**SAN ANTONIO WATER SYSTEM
REGIONAL CARRIZO PROGRAM
BUCKHORN WELLFIELD ACCESS ROADS AND WELL
CONSTRUCTION PROJECT
SAWS JOB NO. 03-8518-207
SOLICITATION NO. B-11-024-MF**

**ADDENDUM NO. 4
JUNE 13, 2011**

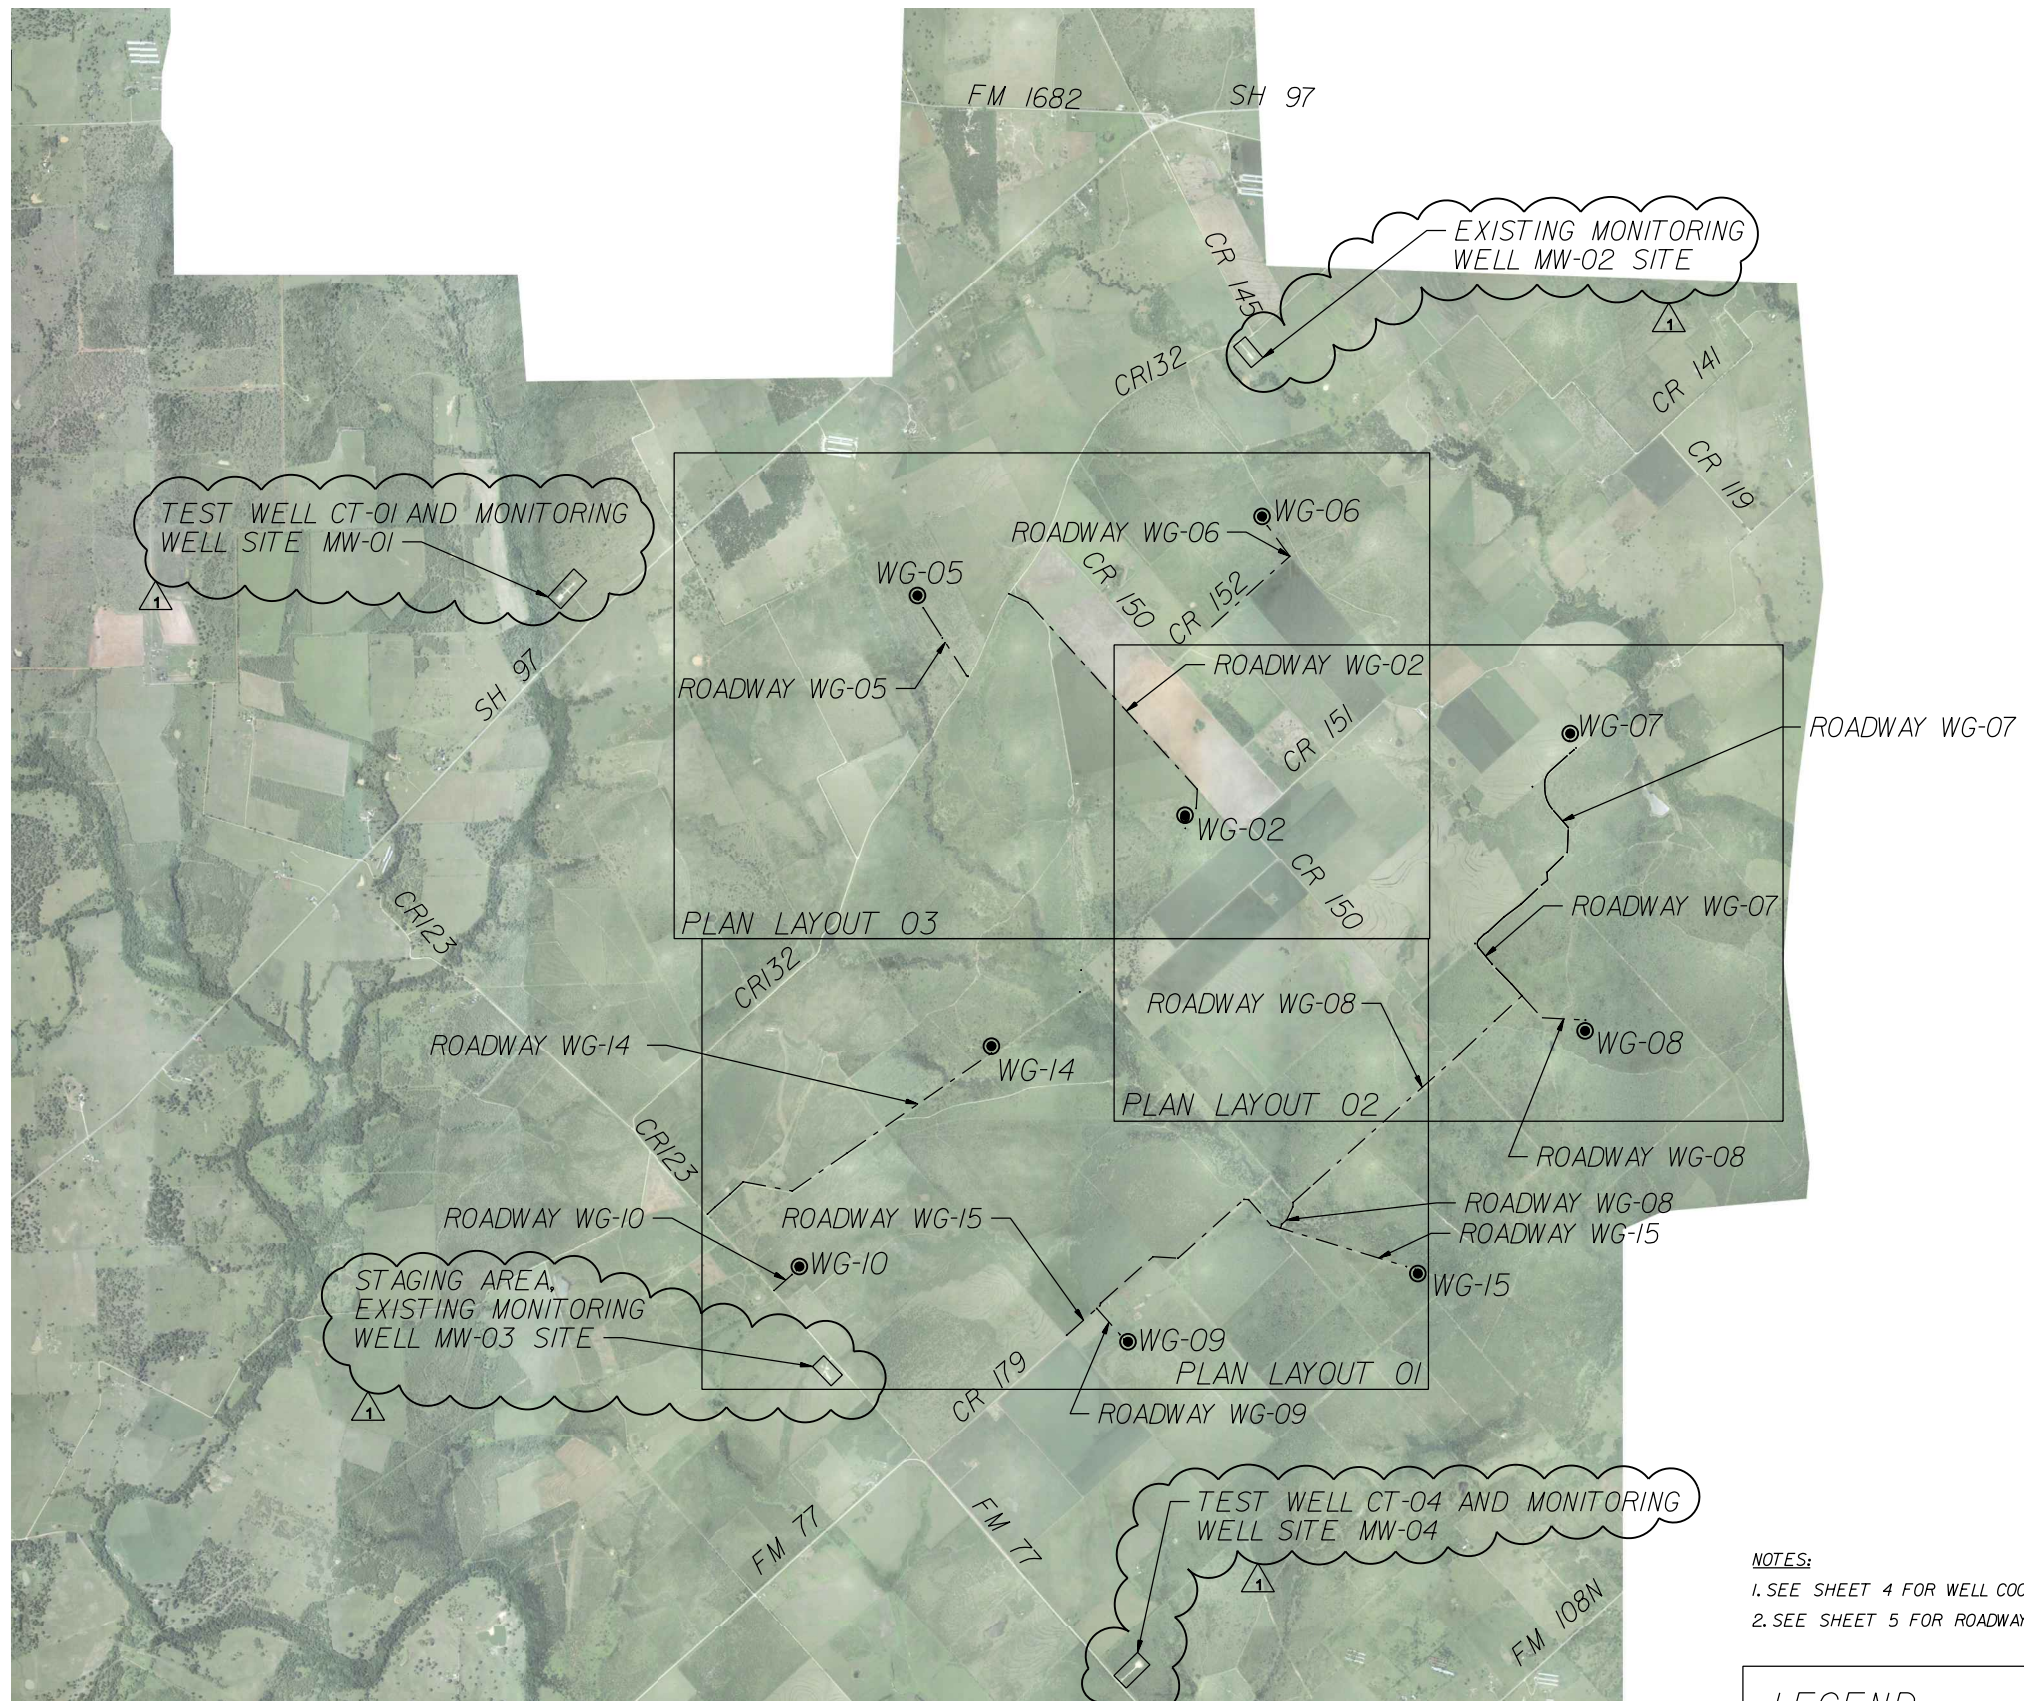
1. SHEET 3 of 25, PROJECT LAYOUT KEYMAP: REPLACE this drawing in its entirety with the attached sheet.
2. SHEET 4 of 25, PRODUCTION WELL SECTION/DETAILS: REPLACE this drawing in its entirety with the attached sheet.
3. SHEET 2 of 25, SHEET INDEX AND GENERAL NOTES: ADD the following note "The Contractor is responsible for maintaining flows in these areas for the duration of the construction activities".

Question: Can SAWS provide a map of the locations of the existing SAWS wells in the area that are available for water for construction use?
Clarification: The locations of SAWS well sites have been added to Sheet 3 included in Addendum #4.

8. **Question:** Can we install a small pump in the monitoring wells for a water supply in not in use for monitoring during test pumping?
Clarification: Yes. See change to Sheet 3 Project Layout Keymap provided in Addendum #4 which provides the locations of SAWS wells. Refer to Section 01500 Paragraph 1.07.E for requirements related to water supply. Also see Addendum #4 for a change in Paragraph 1.07.E.5.
